Dockets Nos. 50-269, 50-270
and 50-287

We have completed our review of adequacy of Station Electric Distribution System Voltages for Oconee Nuclear Station, Units Nos. 1, 2 and 3. Our enclosed Safety Evaluation is based on EG&G Technical Evaluation Report, EGG-EA-6131.

SAFETY EVALUATION
OCONEE NUCLEAR UNITS 1, 2, AND 3
DOCKET NOS. 50-269/270/287
ADEQUACY OF STATION ELECTRIC DISTRIBUTION SYSTEM VOLTAGES

ADEQUACY OF STATION ELECTRIC DISTRIBUTION SYSTEM
VOLTAGES, OCONEE NUCLEAR STATION, UNIT NOS. 1, 2
AND 3

Figure 1. Ocone Electrical Single Line Diagram - Unit 1

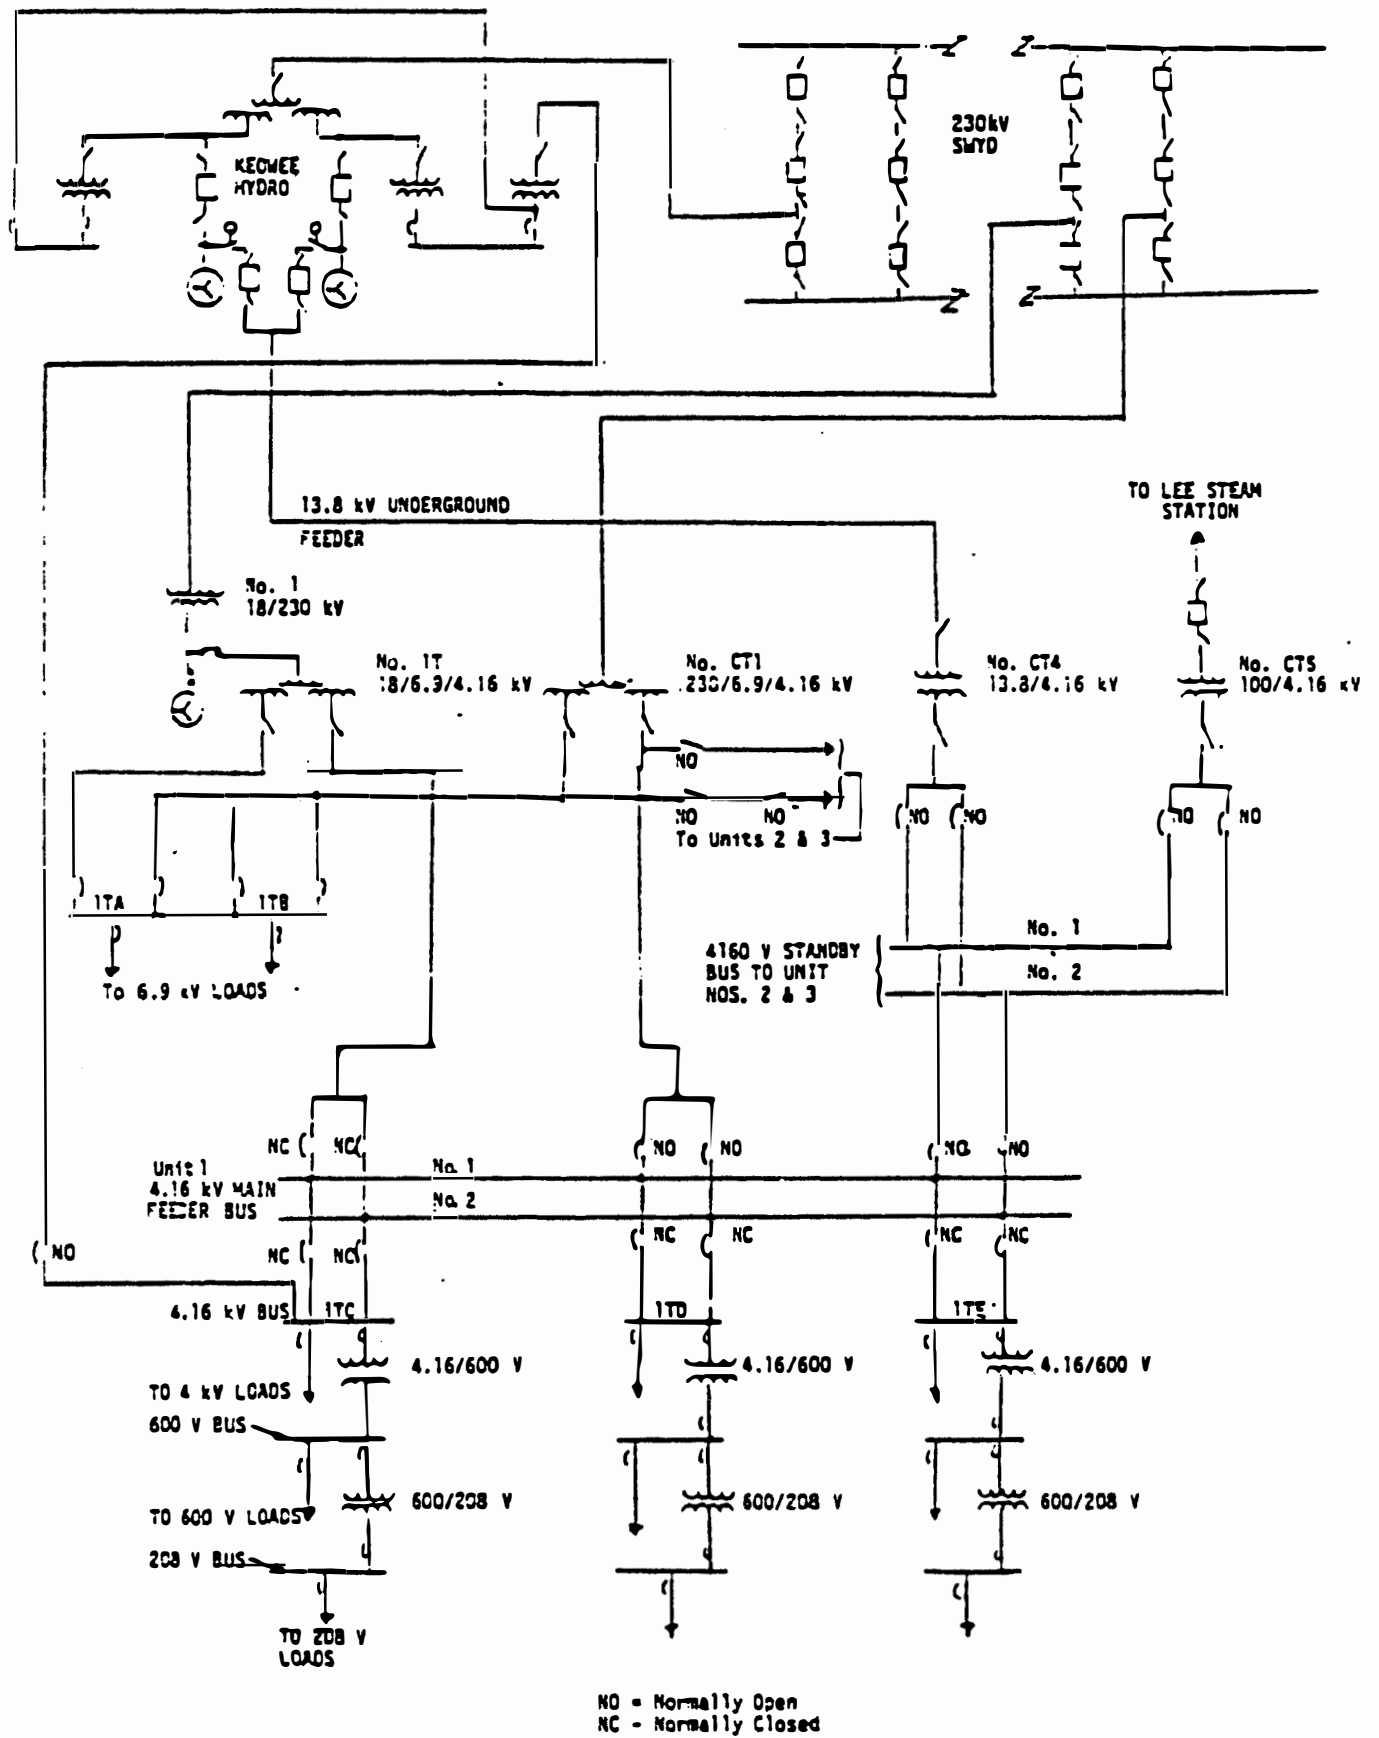
Figure 1 of this report is a simplified sketch of the Oconee electrical single-line diagram. The following description pertains to Unit 1. Unit Nos. 2 and 3 are similar.

During normal plant full-power operation, auxiliary power is supplied by the unit auxiliary transformer No. 1T and during startup and shutdown, by the startup transformer No. CT1 via the 230kV switchyard. Provisions are made for automatic fast transfer of the auxiliary loads from the unit auxiliary transformer to the startup transformer on a unit trip. A second

independent circuit is available from the 230kV switchyard (525kV switchyard for Unit No. 3) to the onsite distribution system via the main transformer and the unit auxiliary transformer for that unit when the main generator bus disconnect links have been removed. Complete loss of all offsite power will result in the automatic transfer to either of the two onsite Keowee hydroelectric generators which are capable of supplying all the emergency and shutdown loads via CT4. Emergency and shutdown loads can also be supplied from a gas turbine generator at the Lee Steam Station via CT5. This generator is isolated from the grid and is considered an onsite source.⁵

There are three essential 4.16kV buses; No. 1TC, 1TD, and 1TE. One division of safety-related equipment is powered from each of these buses. Each bus supplies 4kV loads, the 600V load centers and motor control centers (MCCs), and, in turn the 208V MCC's and the 125/250VDC systems.
